Re: 49 Lauderdale Ave, Fairlight – BCA Assessment Report

The plans reviewed for this assessment are architectural plans prepared by Brenchley Architects, Drawing Nos. 2018-050-A01 to A07 dated June 2019.

The following comments are made in response to DA Condition No. 10 of Consent No. DA2018/0880. This is to assist where clarification is required for the purposes of the Building Code of Australia 2019 (BCA) in relation to submission to Council as part of the S4.55 Modification of the Development Application.

Figure 1 – Section showing proposed Secondary Dwelling beneath Carport

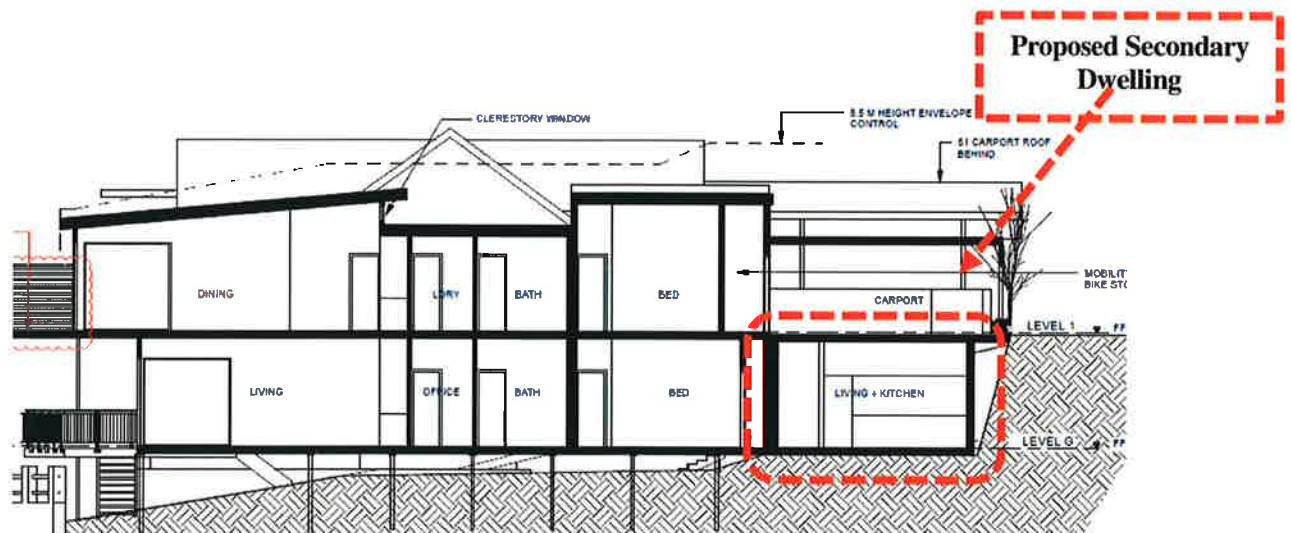
Reference is made to a review of the proposed Secondary Dwelling that is to be located beneath the carport as shown in Figure 1 below. The proposed dwelling at the property is subject of a Development Application for a new Dwelling that is to incorporate a Secondary Dwelling. Northern Beaches Council issued the Notice of Determination for the proposal under DA No. DA2018/0880 dated 16 November 2018.

The floor separating the Ground Floor (Secondary Dwelling) and Carport at Level 1 (Main Dwelling Carport) is to be confirmed as being provided with either;

- An FRL of 30/30/30 when tested from the underside, or
- A floor / ceiling system with a resistance to the incipient spread of fire of not less than 60 minutes, or
- Lined on the underside including supporting beams with a fire protective covering, i.e. 13mm fire grade plasterboard.

The proposed concrete slab and supporting structure separating the Secondary Dwelling from the Main Dwelling Carport is likely to achieve an FRL of 30/30/30 and may be detailed with the Construction Certificate.

Figure 2 – Ground Floor showing Secondary Dwelling and Separating Wall

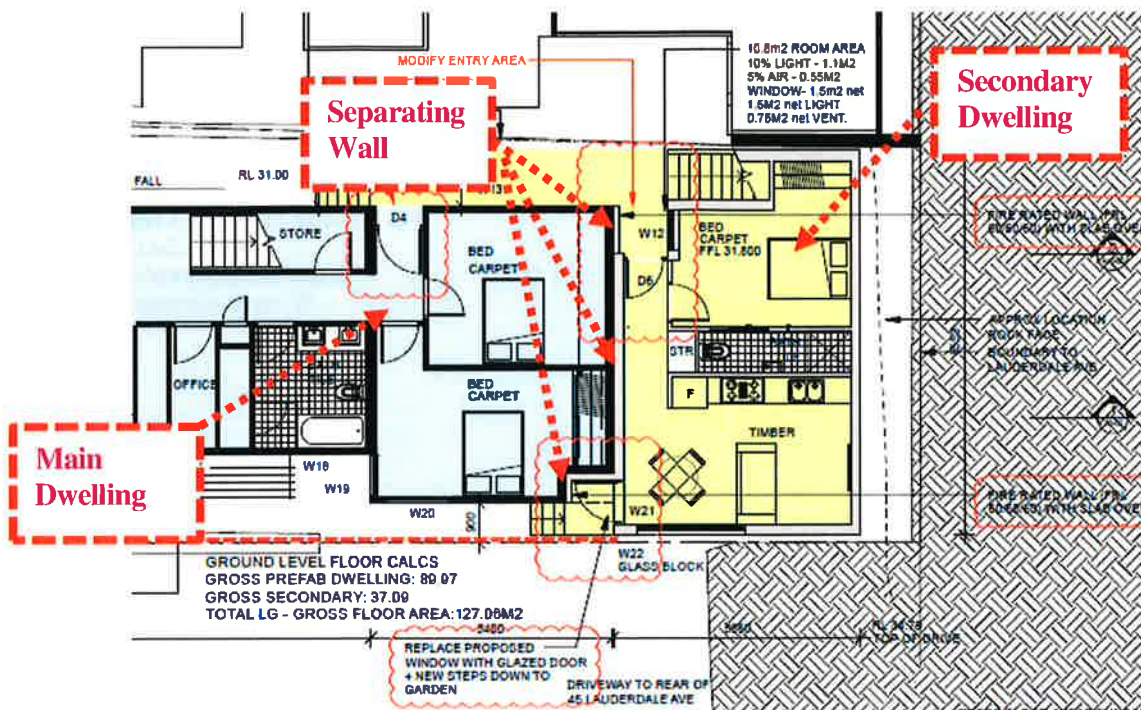
The proposed building contains a Main Dwelling that incorporates a Secondary Dwelling as detailed in the approved DA Consent No. DA2018/0880 dated 16 November 2018. This BCA assessment is in response to Condition No. 10 of Consent No. DA2018/0880 and relates solely to providing comments on the proposed Secondary Dwelling that is to be attached to the Main Dwelling. The main dwelling is to incorporate 2 storeys, being Ground Floor and Level 1 Floor levels. The Secondary Dwelling is to be located at the Ground Floor directly beneath the carport that is attached and forms part of the Level 1 Floor of the Main Dwelling. There is a common separating wall between the Secondary Dwelling and the Main Dwelling at Ground Floor as shown in Figure 2 above.

The external walls (i.e. proposed eastern and western walls of the Secondary Dwelling as shown in Figure 2 above) are less than 900mm from the side boundary, therefore are required to achieve the above FRL. This is likely to be readily achievable and may be detailed with the Construction Certificate. It is noted that no FRL applies to the external walls at right angles to the boundary.

There is a fixed window in the eastern wall of the lounge room of the Secondary Dwelling that is able to be fire rated and may be detailed with the Construction Certificate.

The walls separating the Ground Floor (Secondary Dwelling) and Ground Floor (Main Dwelling) is to be provided with an FRL of not less than 60/60/60. This fire rated wall must extend to;

- The internal separating wall between the Secondary Dwelling and the Main Dwelling is to extend from the eastern elevation to the western elevation as shown in Figure 2 above with the wall having an FRL of 60/60/60, and
- The internal separating wall is to extend from the footings / ground floor slab to the underside of the carport slab to achieve an FRL of 30/30/30, and
- The separating wall may be detailed with the Construction Certificate.
